Technical Service Bulletin - TB019

Date: June 13, 2013

Product: ATC32U01_ Communicating Thermostats.

Incorrect labeling

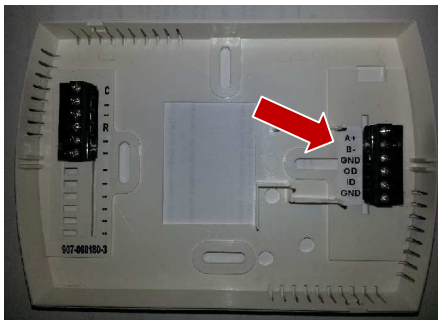
Issue: Incorrect labeling of connection terminal at the thermostat base. The screen print labeling communication connection terminals is placed upside down. If communication harness from the DXM2 board is connected to the terminals as marked (A+ B-) shown below in the picture labeled as "incorrect labeling" will result in communication Error. Thermostats will not communicate with the DXM2 boards.

Solution: ClimateMaster has developed a correct labeling sticker part number 95B0040N01 which can be applied over the screen print to indicate correct connections as shown in the picture labeled "Correct labeling". Stickers can be ordered through normal warranty parts ordering process. Connect communication harness/wires according to the correct labeling to correct the communication error.
